DESCRIPTIVE REPORT

Field No. BQ-1351 Office No. H-7898

Locality Pinole Point
to
Davis Point

REVIEW OF HYDROGRAPHIC SURVEY

S A N
P A B L O
(chart 5533)

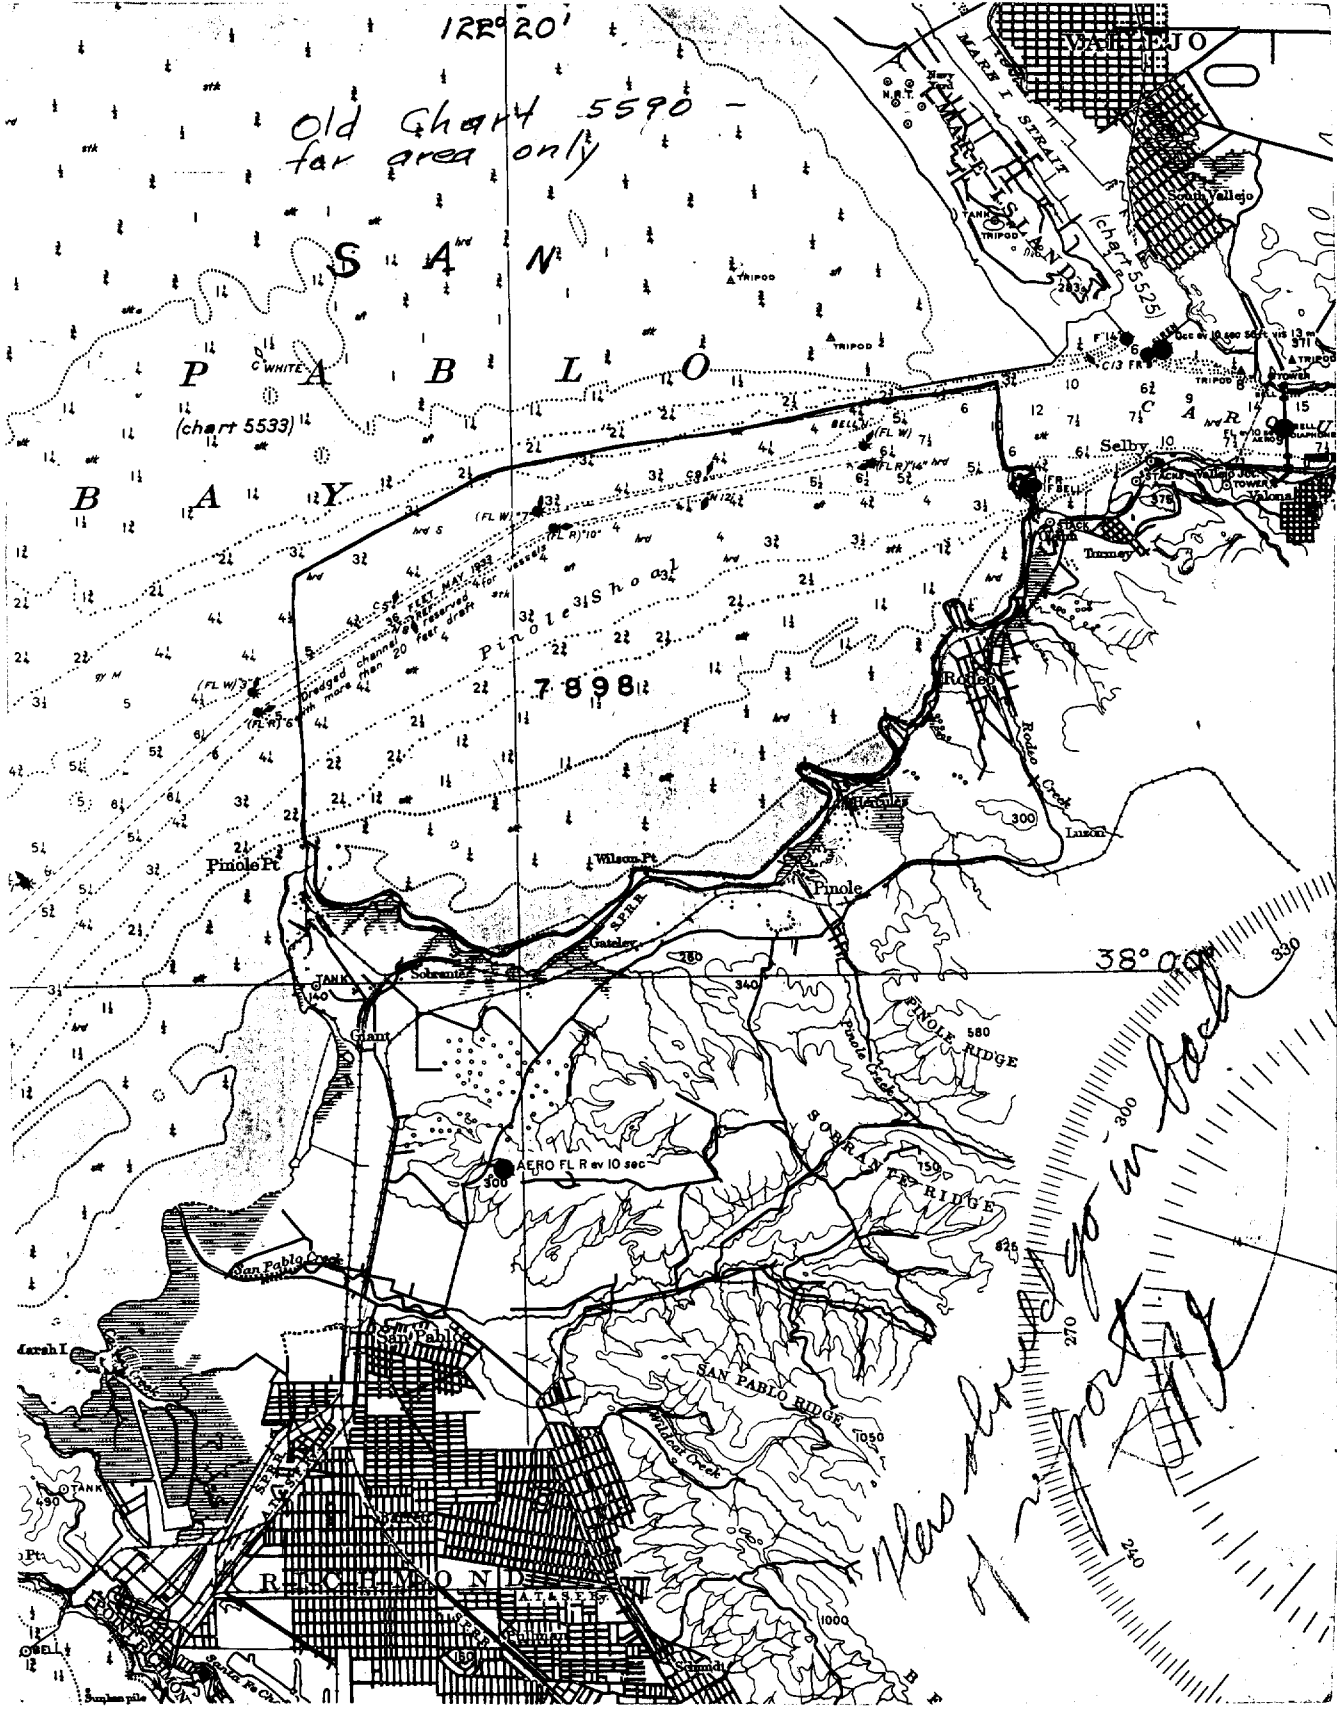
1. The piers charted in lat. $38^{\circ} 00.73'$, long. $122^{\circ} 17.80'$ and lat. $38^{\circ} 01.33'$, long. $122^{\circ} 16.90'$, respectively, are not shown on survey T-5931 (1943-44) or graphic control surveys BO-B and C-51. They are considered to be non-existent.

2. The 3 piles charted at Pinole Point in the vicinity of lat. $38^{\circ} 00.8'$, long. $122^{\circ} 21.6'$, were not found after a careful search during the present survey. The hydrographer's recommendation on page 4 of the Descriptive Report to delete these piles is concurred in.

3. The 19 ft. charted in lat. $38^{\circ} 02.93'$, long. $122^{\circ} 19.48'$ and the 21 ft. charted in lat. $38^{\circ} 03.13'$, long. $122^{\circ} 18.61'$ from the Corps of Engineers' survey of 1947 (Bp. 42498) fall in a flat area of mud and sand bottom where present depths, 7 ft. deeper, discredit the existence of these shoals. The Corps of Engineers soundings of 19 and 21 are probably in error because of faulty fathometer operation or fathogram interpre- 38°
NEM.

The 29-ft. sounding charted in lat. $38^{\circ}03.2'$, long. $122^{\circ}17.3'$ was found to have been plotted incorrectly. Its true position, about 300 meters south of the charted position, is well within the 30-ft. curve. The charted "29" and its isolated curve should be deleted from the chart.

The present survey supersedes the charted hydrography.
